IN THE DRAWINGS:

REMARKS

Fig. 3

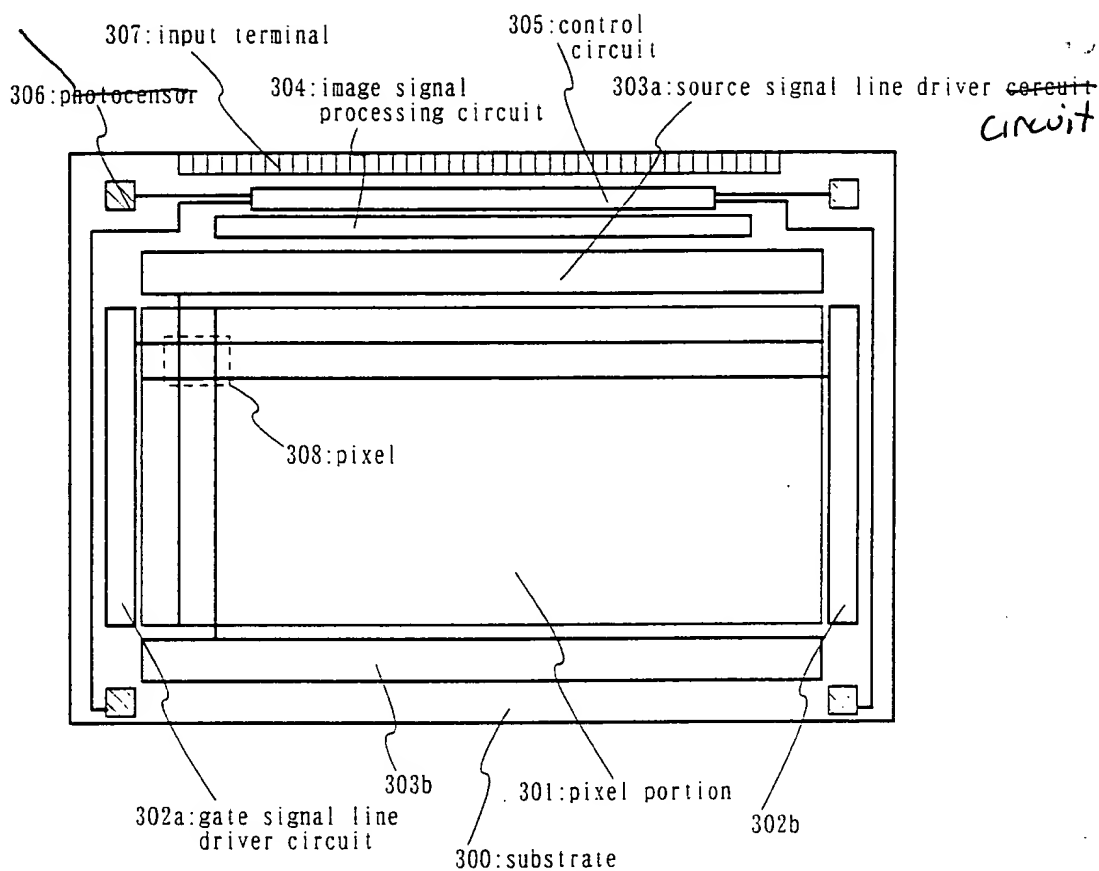
Upon preparation of the formal drawings, Applicants noted that there were several misspelled words in Figs. 3 and 15 and an incorrect lead line in Fig. 5B. Applicants are amending each of these drawings to correct these informalities. No new matter is being added. Therefore, it is respectfully requested that this amendment be entered and allowed.
